City of Richmond
Planning & Development

General Compliance Request

To: Development Permit Panel
From: Jean Lamontagne
Director of Development
Date: April 25, 2006
File: DP 04-287638
Re: **Application by Patrick Cotter Architect Inc. for a General Compliance at
7171 Steveston Highway**

REVISED SITE PLAN

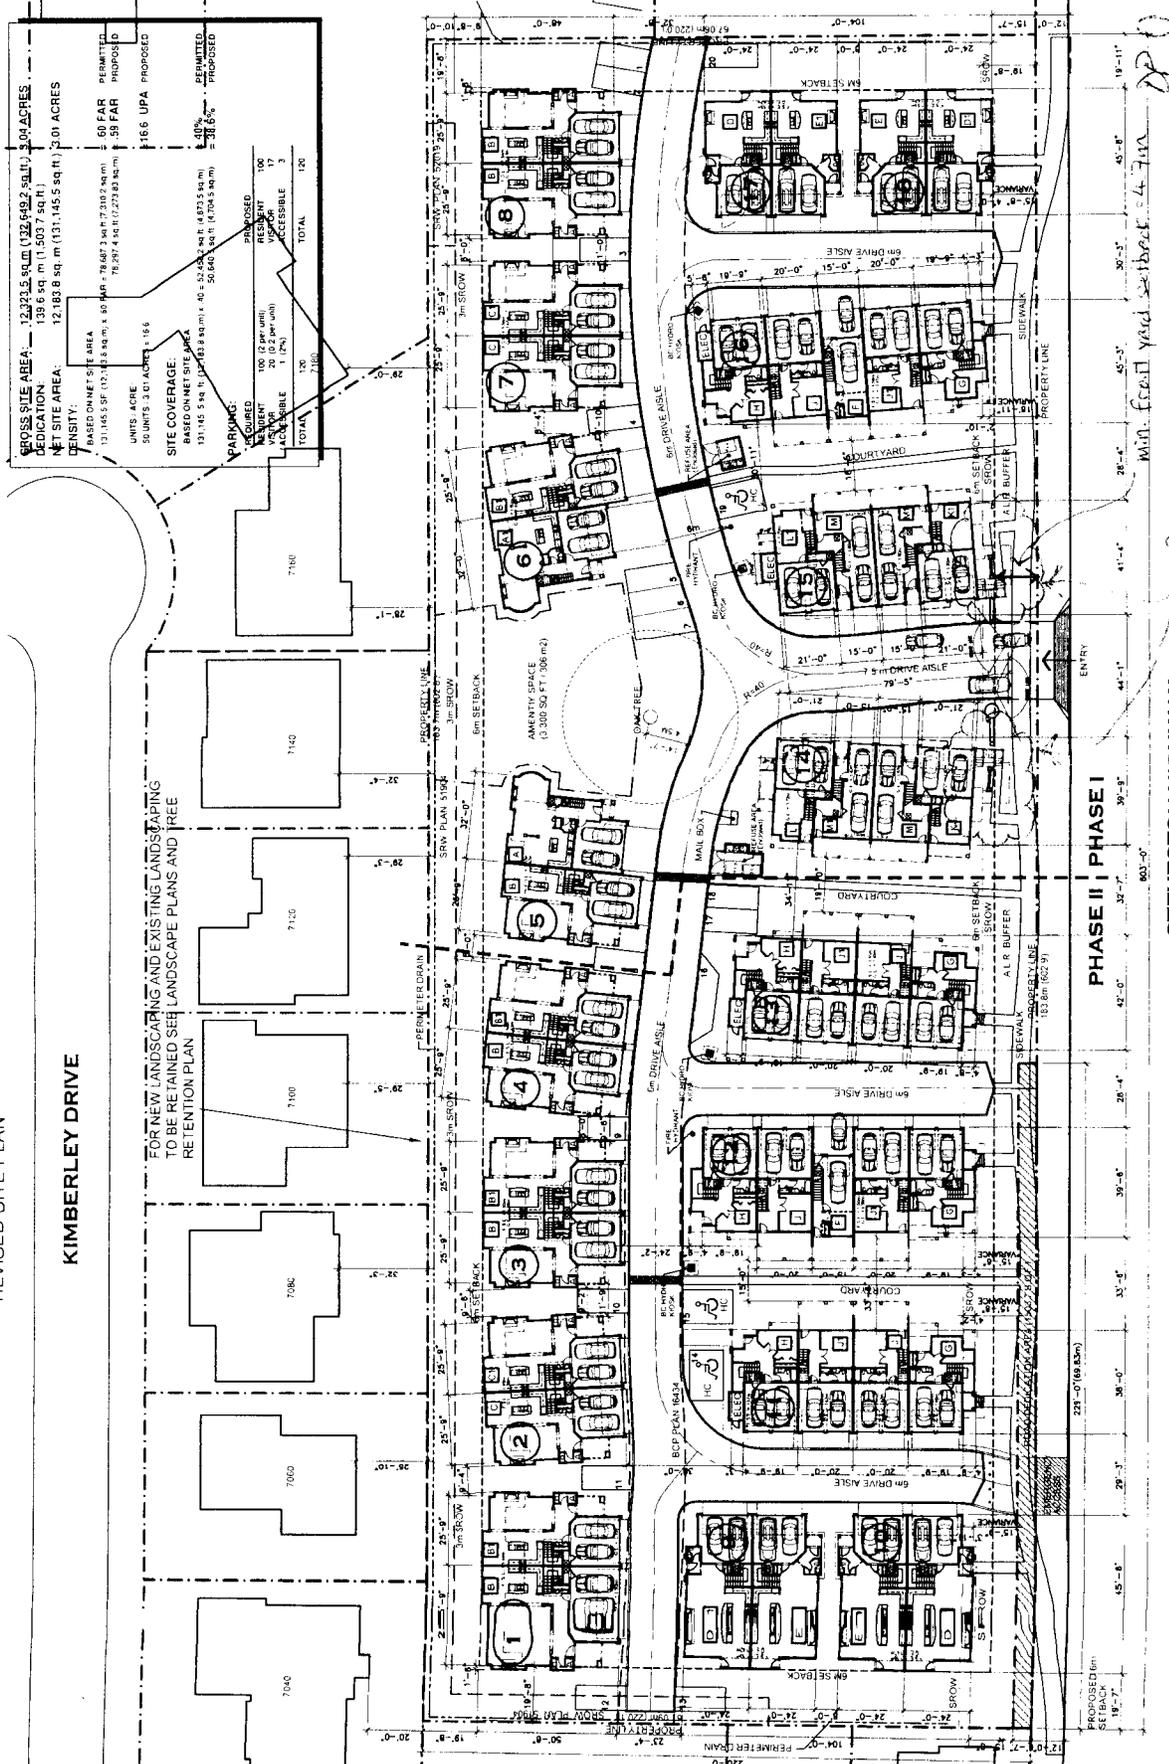
1. Modification of the entrance stairs and porches on the front elevations (facing Steveston Highway) of Buildings 14 & 15 (**Attachments 2 - 6**);
2. Addition of dormers on Buildings 12 & 16 (**Attachments 7-10**);
3. Revision of landscaping/berming along Steveston Highway (**Attachments 11-12**), including:
 - a. addition of a 2 ft. high retaining wall (facing inward) across the Steveston Highway frontage; and
 - b. addition of solid fence in the private outdoor spaces which abut Steveston Highway.

BUILDING No. 14,15
 ELEVATIONS
 EAST WEST
 DP 04-287638

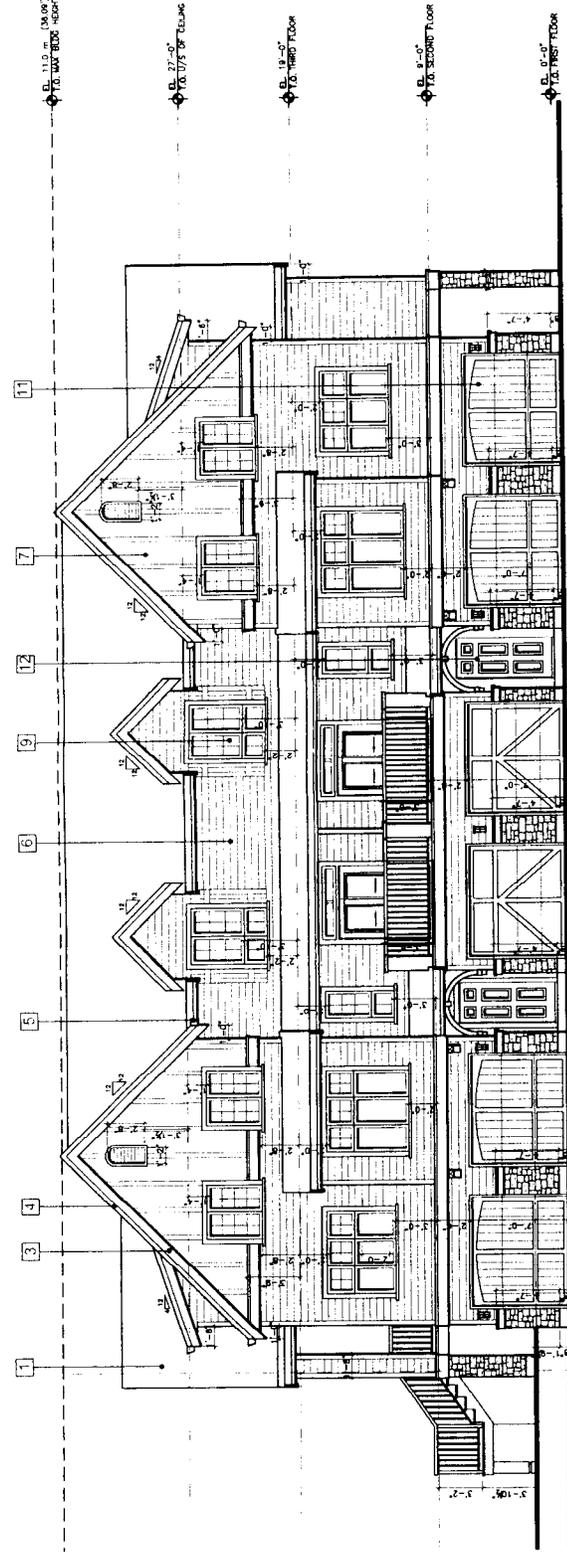
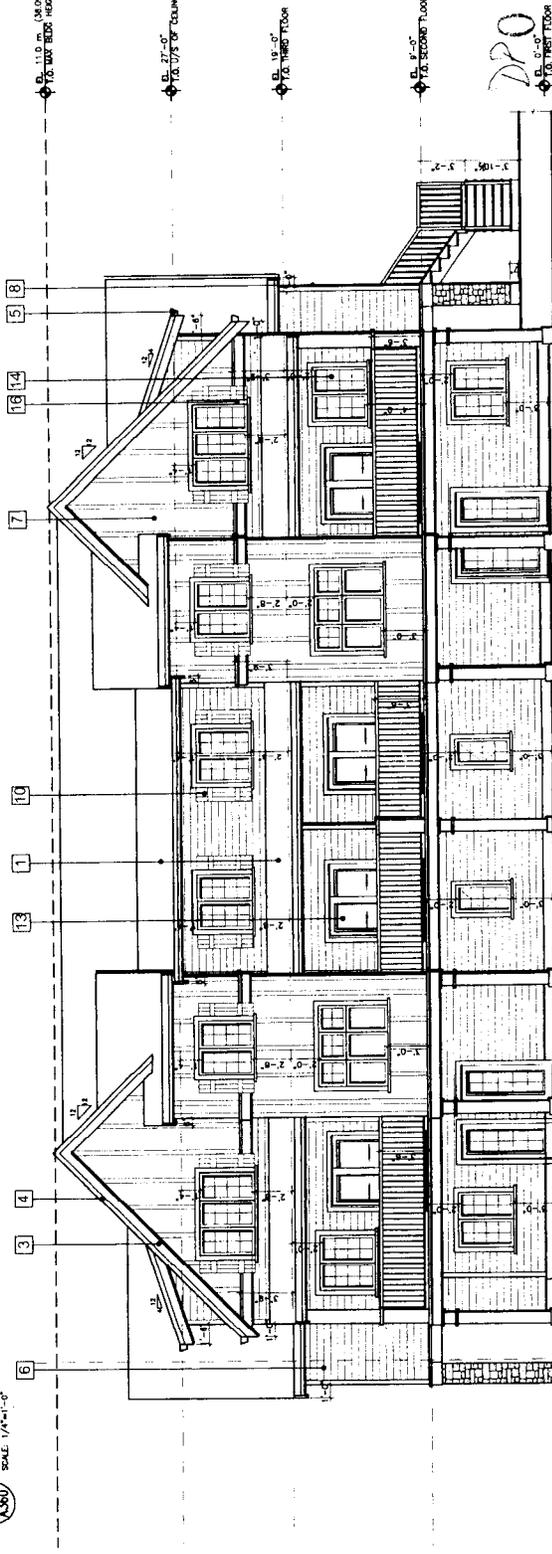
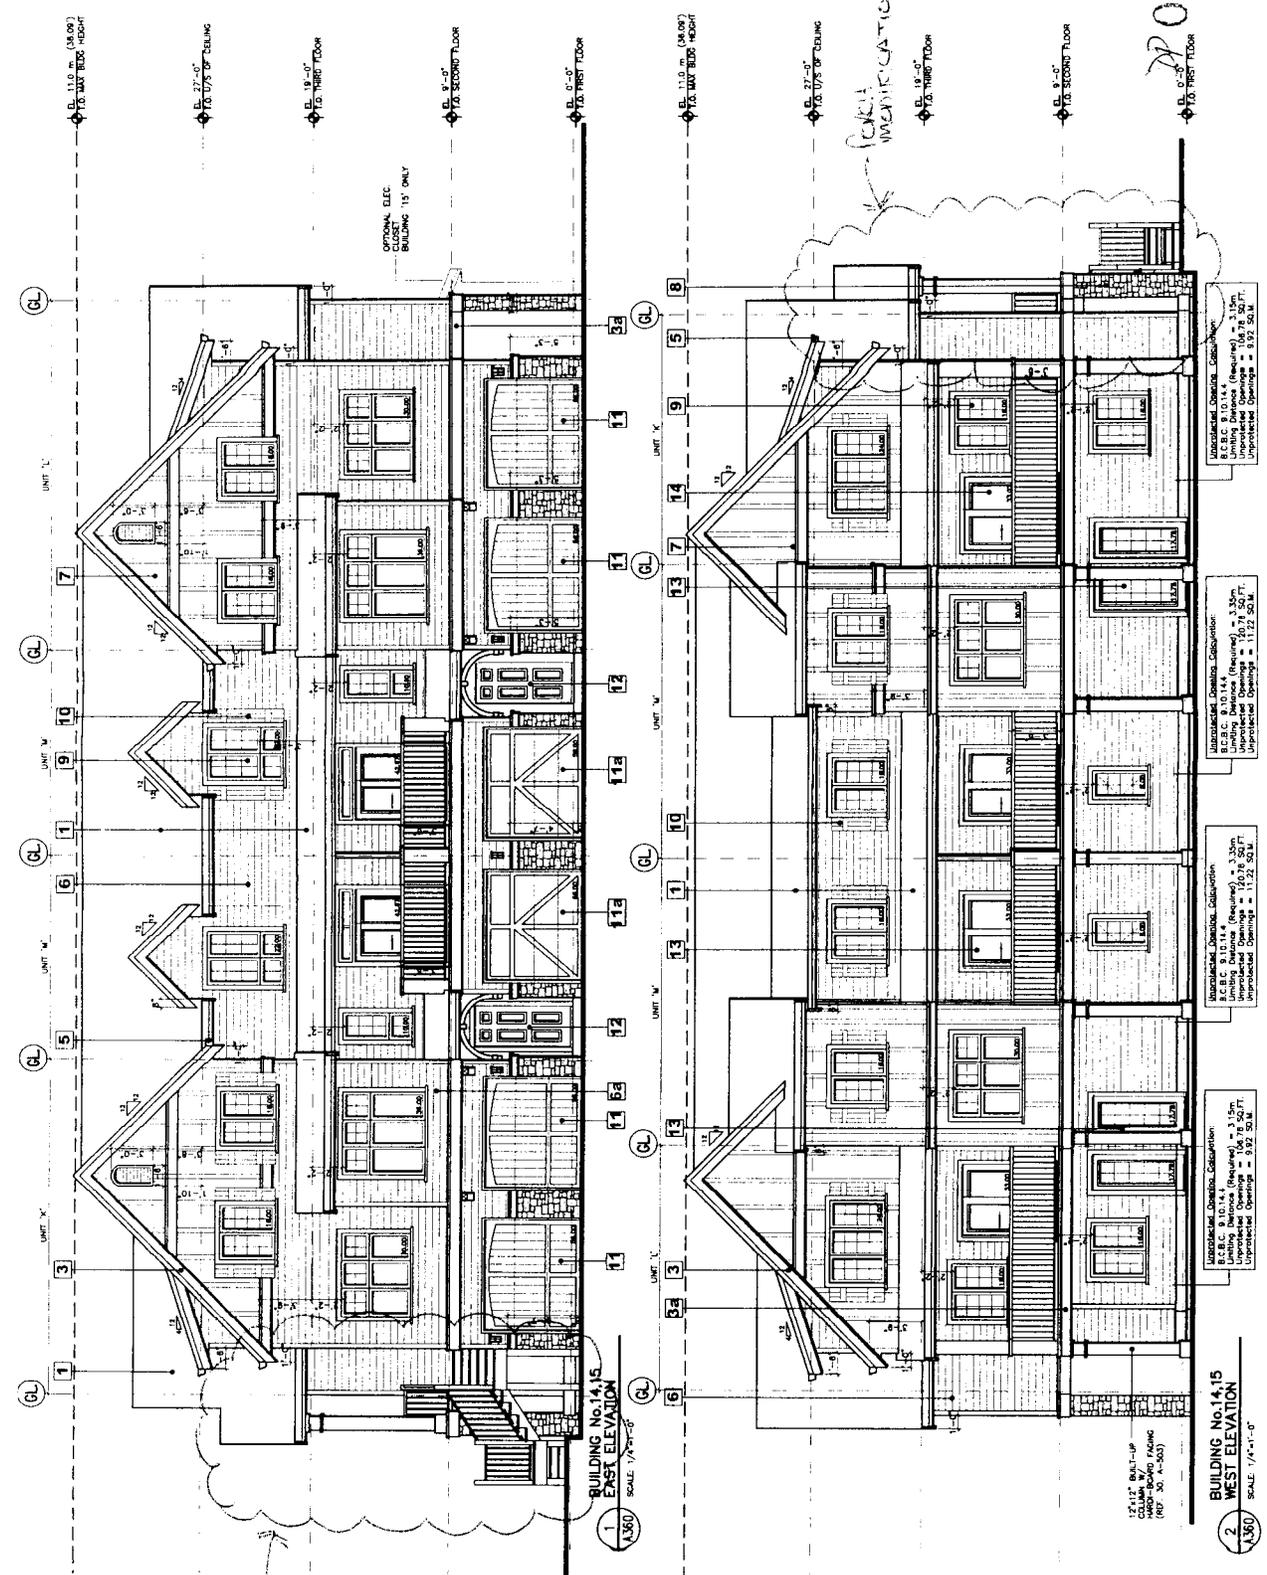
The final sidewalk grade is approximately 16" lower than anticipated resulting in nearly a full flight of stairs at the entrance of the end units facing Steveston Highway in Buildings 14 & 15. The applicant is proposing to enhance the elevation with the addition of a small gable over the entry door (**Attachments 4 & 6**). The gable will be supported by two (2) columns and situated on a stone-clad entrance landing. The stairs will be longer and project slightly into the Statutory Rights of Way (S.R.W.) but will setback further from the front property line than the original design. Engineering staff have no objection to the encroachment as there is no utilities within the S.R.W. The S.R.W. is intended to provide a Landscape Buffer to the Agricultural Land Reserve (A.L.R.) properties located across Steveston Highway. The owner would be solely responsible to remove/relocate the stairs upon request from the City when it deems necessary for such an action.

An Encroachment Agreement is required to accommodate the stairs projecting into the S.R.W. This Agreement must be signed by the developer prior to the General Compliance Request being forwarded to Council. The Agreement will include language to ensure the stairs will be removed/relocated at the owner's cost when required by the City and any liability to Richmond in the premises be relieved.

BUILDING No. 12.16
ELEVATIONS
EAST / WEST

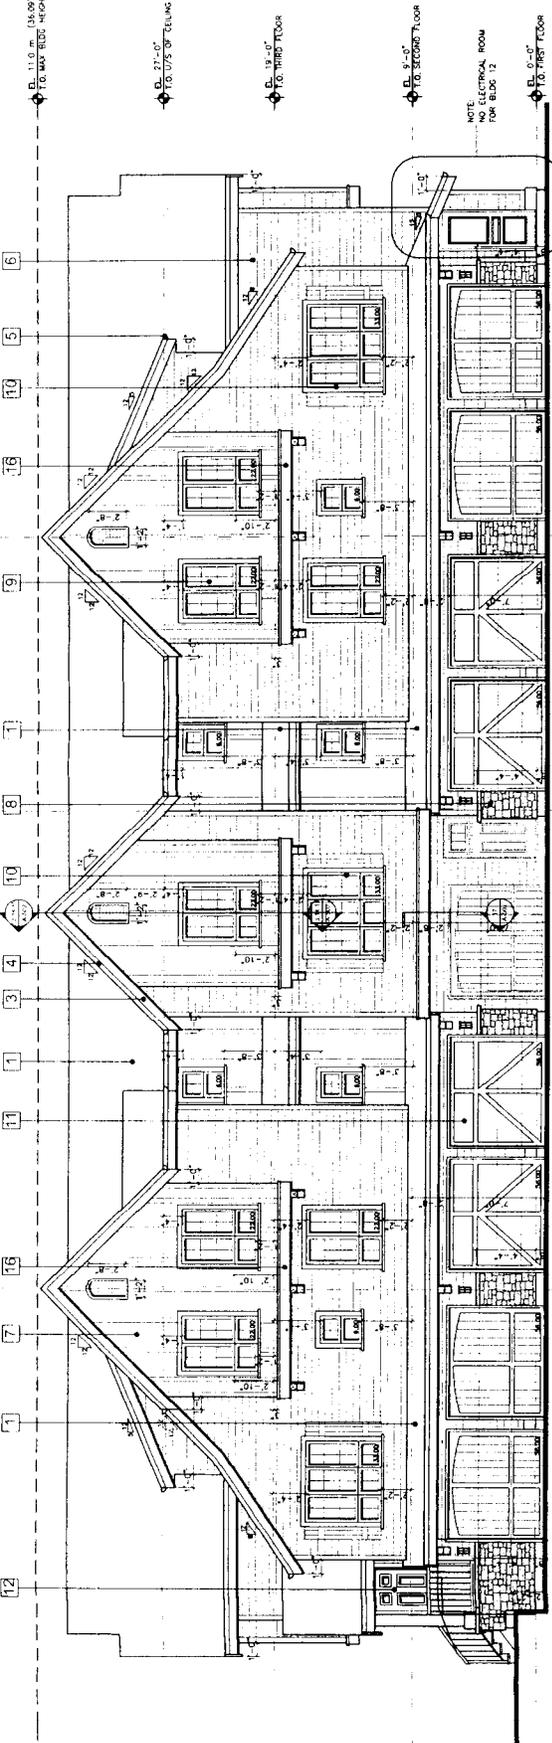
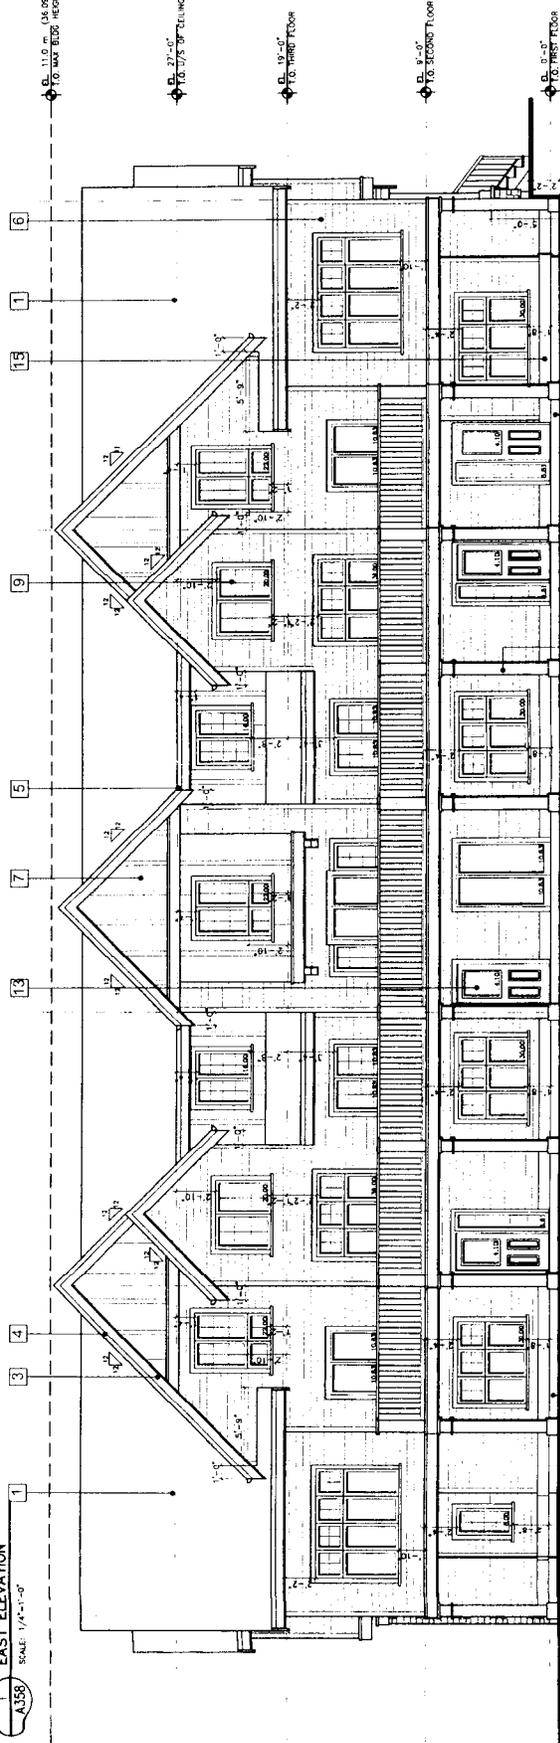
In order to eliminate a substantial sloped ceiling in the upper bedroom of the end units in Buildings 12 & 16, the applicant is proposing to add shed roofs to the upper roofs as shown on **Attachments 8 & 10**.

The proposed addition would affect the floor area ratio (F.A.R.) for the project. The applicant has recalculated the F.A.R. for the entire project and found the total to be slightly lower than that of the Development Permit due to slight variations as a result of developing working drawings. The proposed F.A.R. is 0.597. Site coverage on the other hand increased from, 37.98% to 38.61% as some of the covered areas (by decks) was not counted at Development Permit stage, but the total site coverage was still under the maximum allowed in Townhouse District (R2-0.6).

REVISED LANDSCAPE PLAN

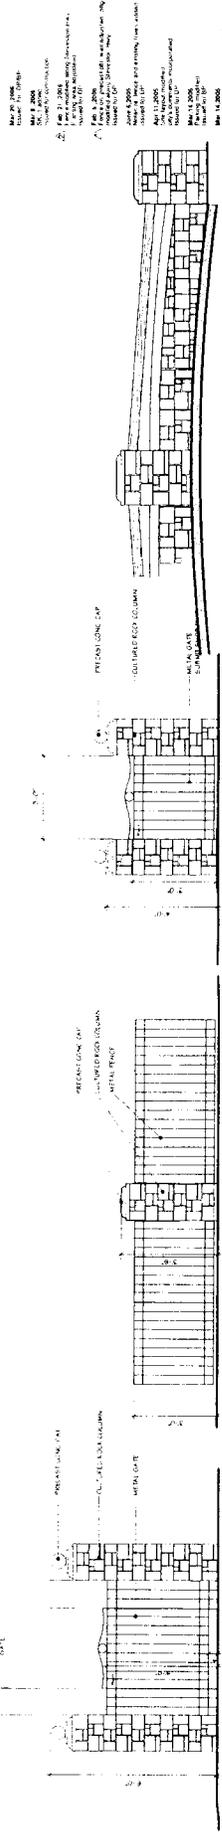
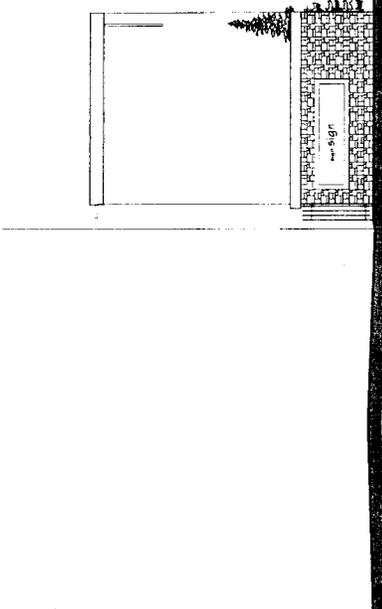
Initially, the developer envisions a significant berming within the boulevard and setback area to create natural shielding (**Attachment 11**). However, the grading has to be adjusted to meet Engineering Department requirements. Since the final sidewalk grading is more gradual than initially envisioned, the applicant is proposing an alternate landscape and fence treatment along the Steveston Highway frontage (**Attachment 12**). The proposed retaining walls (approximately 2 ft. high) provide for additional berming in front of the units between the street and buildings. The solid fence at the easternmost and westernmost building yards (the private outdoor spaces which abut Steveston Hwy) provides further noise buffering and landscaping will screen the fence from Steveston Highway. The details of the proposed solid fence and a cross-section of the retaining walls are provided on Sheet #3 of the Revised Landscape Plan (**Attachment 12**).
